## REFERRAL DOCUMENT

### Planning Application referral to City Design

To be filled in by Planner	
<b>Application number:</b>	1389/2021
<b>Address:</b>	448 St Kilda Road, Melbourne
<b>Applicant:</b>	Contour Consultants Australia P/L
<b>Planner:</b>	Kate Wooller
<b>Date of Referral:</b>	28/1/22
<b>Date to be completed</b>	
<b>TRIM References:</b>	
<b>Referral Type</b>	Urban Design – Att: David O'Reilly
<b>Overlays</b>	DDO13, DDO26, SBO1
<b>Contributory Heritage Place (outside HO)</b>	No
<b>Planning Zone</b>	Commercial 1
<b>Proposal Summary</b>	DEVELOPMENT OF THE LAND FOR A MIXED USE BUILDING COMPRISING RESIDENTIAL HOTEL, DWELLINGS AND FOOD AND DRINK PREMISES (NO PERMIT REQUIRED FOR THESE USES), USE OF THE LAND FOR THE PURPOSE OF A DAY SPA, SALE AND CONSUMPTION OF LIQUOR AND A REDUCTION IN THE STATUTORY CAR PARKING REQUIREMENT
<b>Relevant documents</b>	Refer to Application documents and plans folder – various documents are available with key items as follows:  Enviro Wind assessment – 6182732 Planning Submission report – 6182730 (includes Design Response, BADS assessment, illustrations and discussion alongside DDO's etc) Plans – 6182729 St Kilda Landscape Presentation and Plans comb

Lower Ground

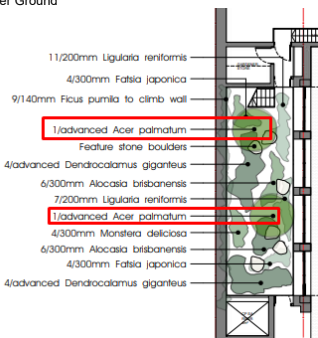
Not Tree Type A, B or C.

Ground floor

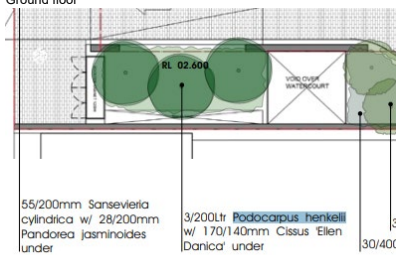
Possibly Tree Type A and B. Very limited information on this species.

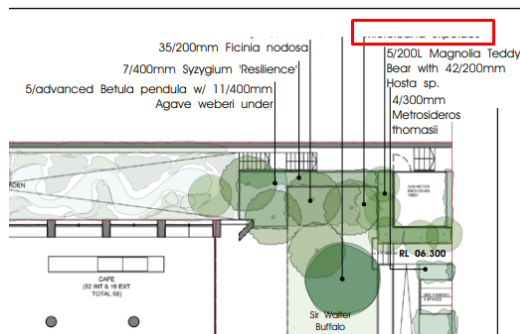
Need tree name. Previous landscape plan indicated planting of *Quercus palustris*, which meets criteria for Tree Type C.

Canopy cover surface area – Ground floor plan  
3.5, 7, 35, 41, 58, 225 = ~369m<sup>2</sup> of canopy cover.

2 ST KILDA ROAD SETBACK  
A200 SECTION 1:100

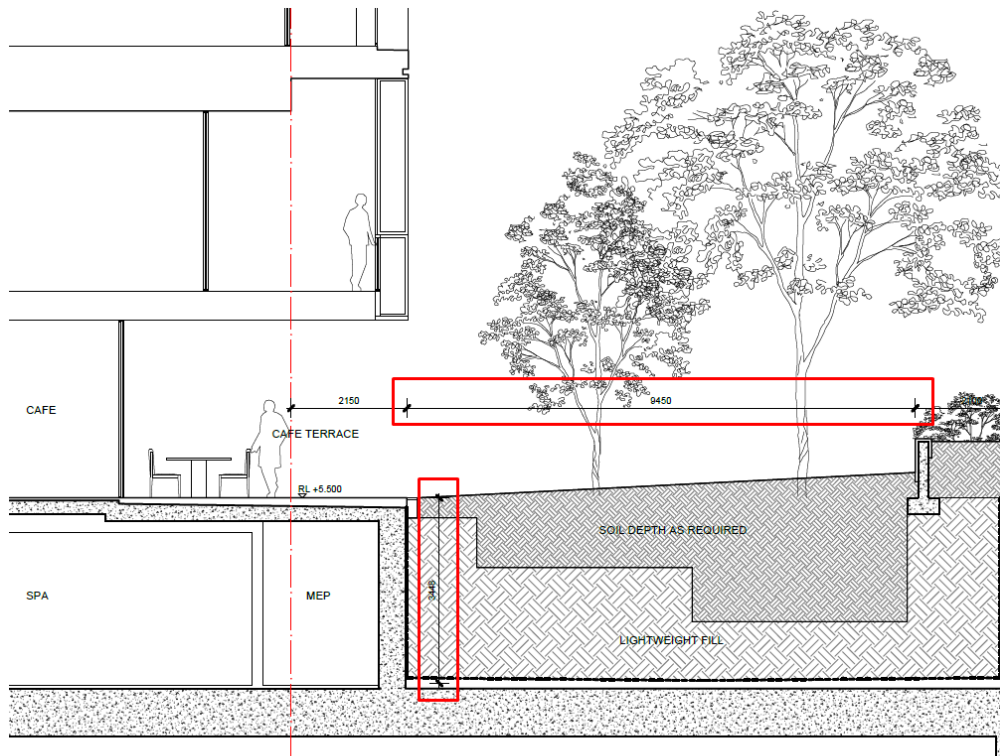
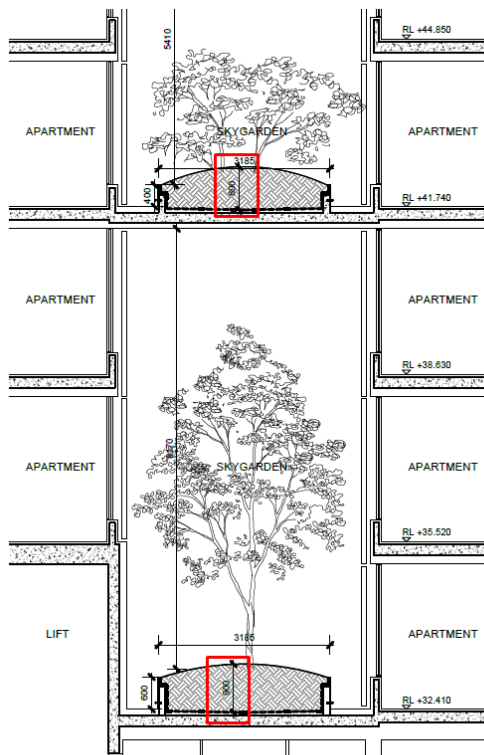
Meets minimum soil depth, width and volume for Tree Type C. Soil surface area = ~140m<sup>2</sup>.

3 APARTMENT SKY GARDENS  
A200 SECTION 1:100

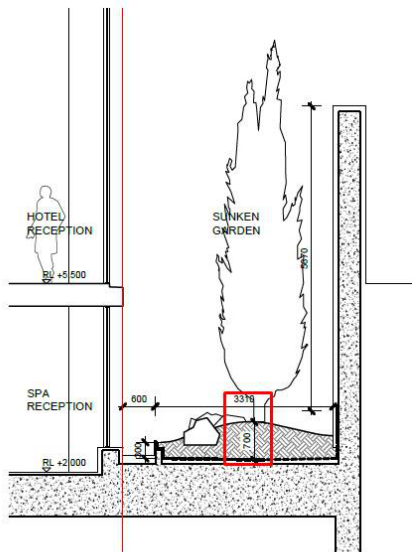
Does not meet minimum soil depth for Tree Type A. Soil surface area = 0m2.

4 SUNKEN GARDEN TO SPA SECTION 1:100

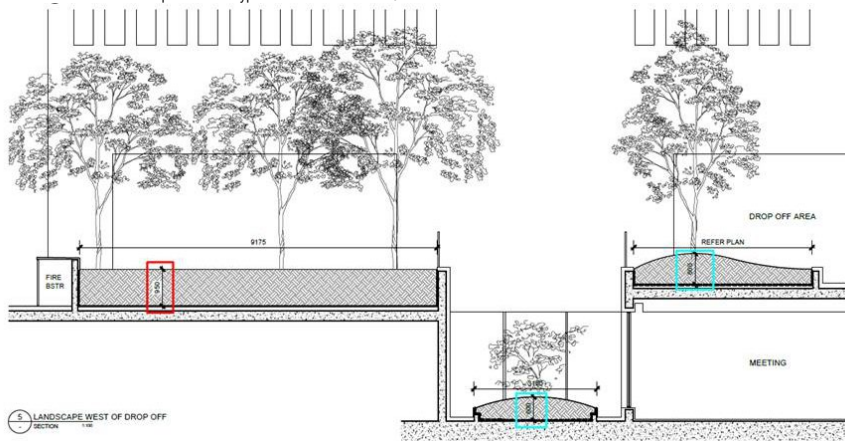
Does not meet minimum soil depth for Tree Type A. Soil surface area = 0m2.

5 LANDSCAPE WEST OF DROP OFF SECTION 1:100

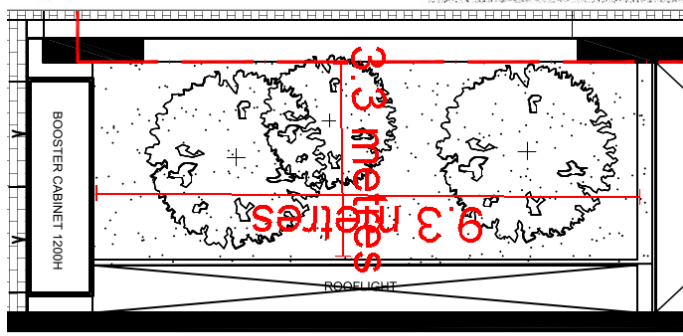
Section closest to Fire Booster meets minimum soil depth for Tree Type A for soil depth, width and volume. Soil surface area = ~31m2.

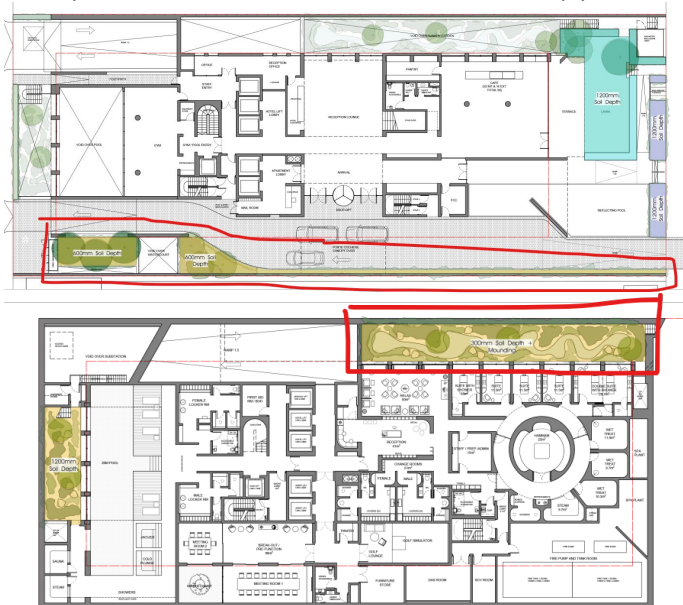
The following areas, identified in red highlight, from the ground floor and lower ground do not meet the requirements of Table D3 and therefore do not comply with 58.03.
